Product Change Notice (PCN)

PCN Number: **PCN-0456166R**

Product(s) Affected: **PJ-036CH**

PREVIOUS CUI DEVICES DETAIL / IMAGE	NEW CUI DEVICES DETAIL / IMAGE

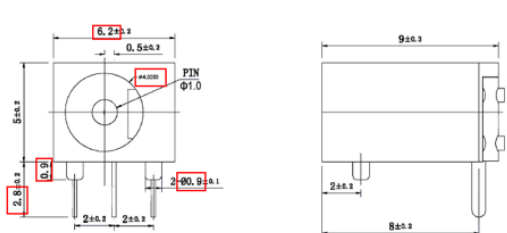
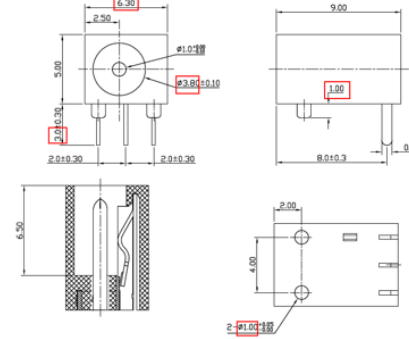
Description of Change: **New Factory Location. Product re-engineered for improved manufacturability and production yield. See image below for reference and check CUI Devices website for updated drawing. Cosmetic differences may be visible and not affect the form fit and function of the product.**

PREVIOUS CUI DEVICE'S DETAIL / IMAGE			NEW CUI DEVICE'S DETAIL / IMAGE		
DESCRIPTION	MATERIAL	PLATING/COLOR	DESCRIPTION	MATERIAL	PLATING/COLOR
center pin	brass	silver	center pin	brass	silver
terminal 1	brass t=0.25	silver	terminal 1	brass t=0.25	silver
terminal 2	brass t=0.25	silver	terminal 2	SUS301 t=0.25	silver
terminal 3	brass t=0.25	silver	terminal 3	brass t=0.25	silver
housing	PBT (UL94V-0)	black	housing	PPA (UL94V-0)	black

MATING PLUG
Jack Insertion Depth: 6.4 mm

MATING PLUG
Jack Insertion Depth: 6.5 mm
